Palo Verde Nuclear
Generating Station

102-05989-DCM/GAM
April 14, 2009

**Subject: Palo Verde Nuclear Generating Station (PVNGS)
Units 1, 2 and 3
Docket Nos. STN 50-528, 50-529, and 50-530
Supplement 1 to License Renewal Application**

Figure 4.5-2: Regression Analysis of Unit 1 Vertical Tendon Lift-off Data Through the 15-Year Surveillance; With Reg Guide 1.35.1 Predicted Prestress (See Notes)

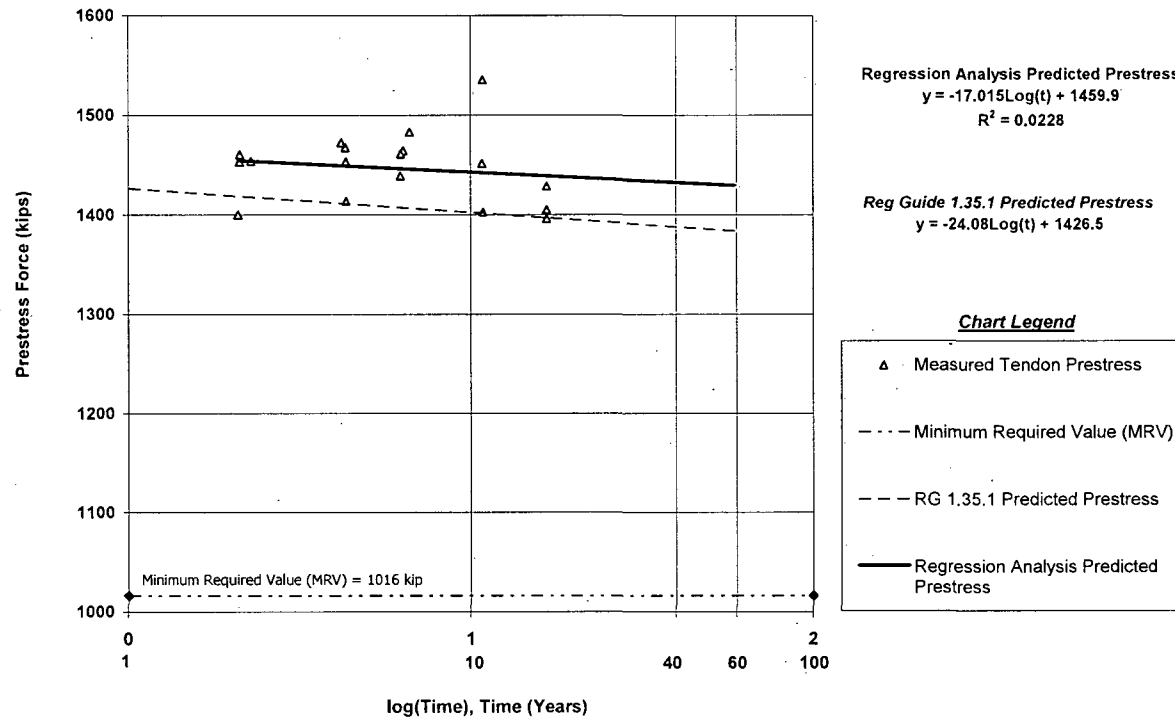
- Figure 4.5-2

Extended the Regulatory Guide 1.35.1 Predicted Prestress graph values to 60 years.
